CITY OF WARSAW, MISSOURI
MAIN STREET COMPLETE STREETS
PRELIMINARY ENGINEERING REPORT
REVISION 07-12-2019

ADDEDUM TO THE 04/27/2016 COOK FLATT & STROBEL ENGINEERS REPORT

Proposed Typical Section

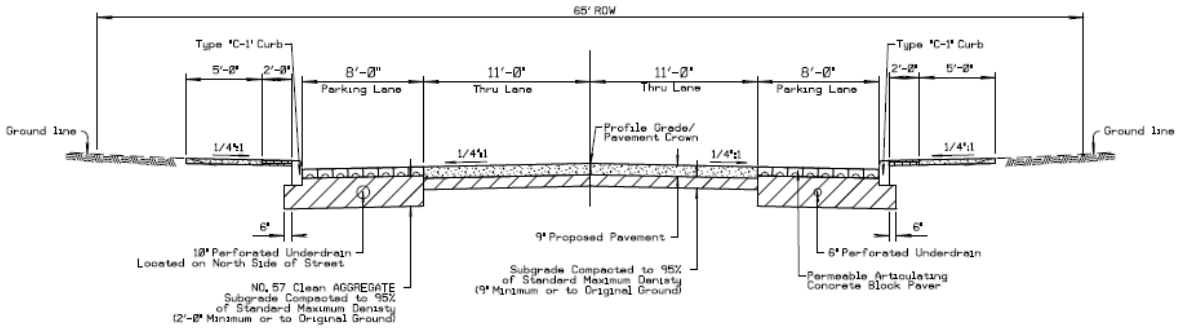
The proposed improvements to the section of Main Street included in Phase III A will consist of full-depth removal of the existing asphalt and subgrade, which will be replaced with 11' asphalt lanes. Other improvements in this area will also include 'Type C' curb, 5' Sidewalks, enclosed storm sewer, signage, and street lighting. Defined property entrances should be constructed, with a maximum width of 30'.
